# Service Letter

## SL-MD10-003-R01

Use of the JS3 Parking Brake

Figure 1: Stick with wheel brake system

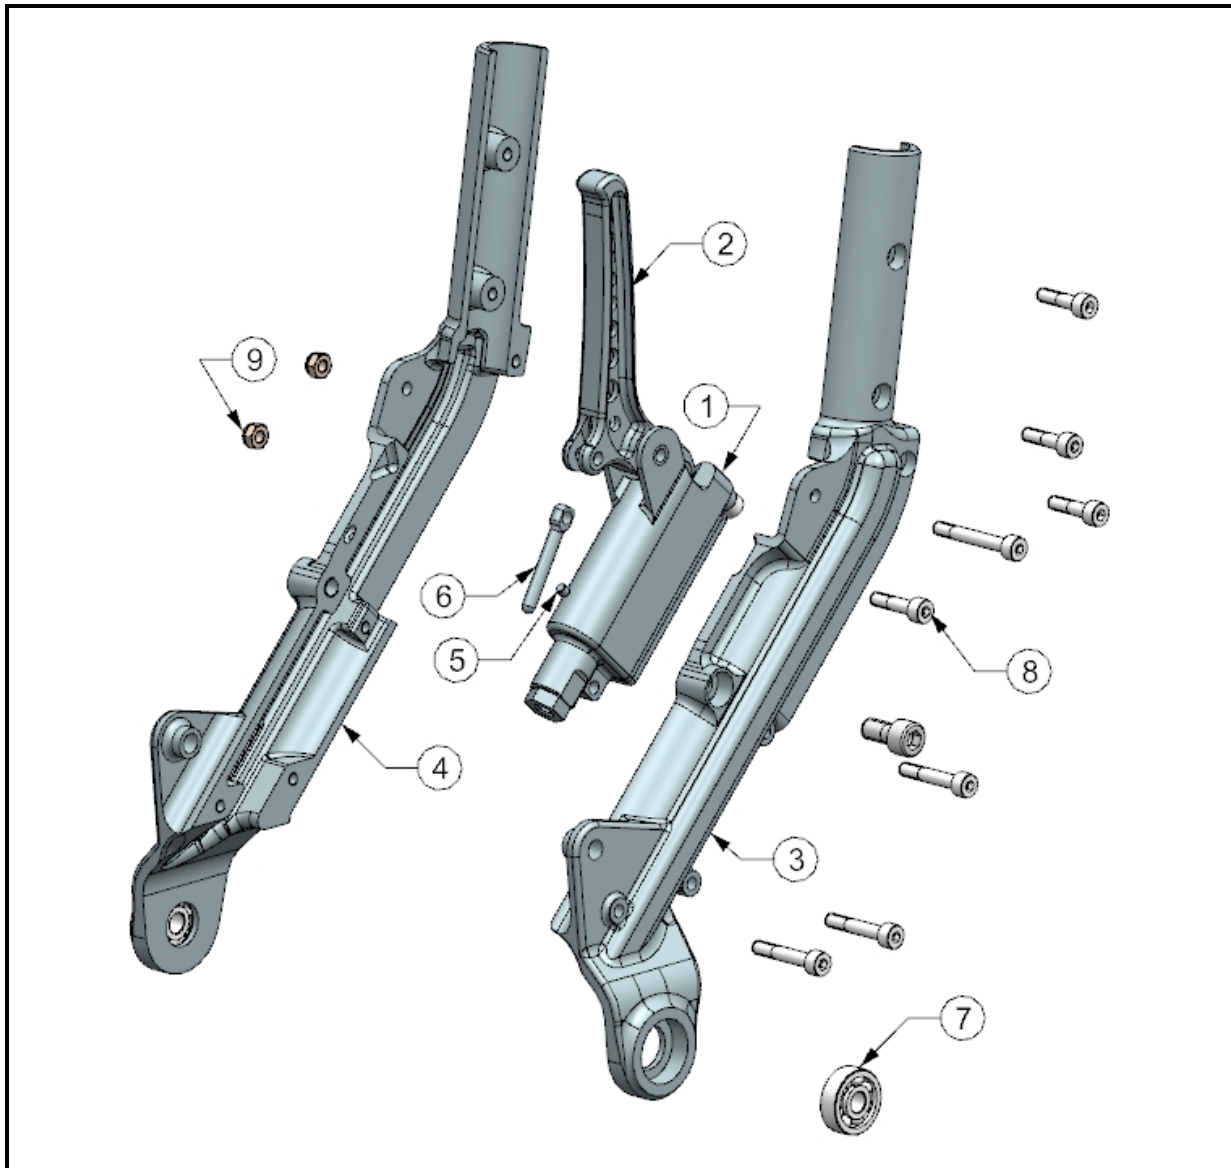
The parking brake is activated by a free-swivelling pin (Figure 1, Item 6) connected to the wheel brake lever (Figure 1, Item 2), which can be engaged in a recess when the brake lever is applied hard and the pilot directs the pin to the recess.

The parking brake pin is automatically disengaged by a spring when the wheel brake lever is applied sufficiently.

*Operators are strongly recommended avoiding the use of the park brake pin until RSB SB-MD10-006 has been performed.*
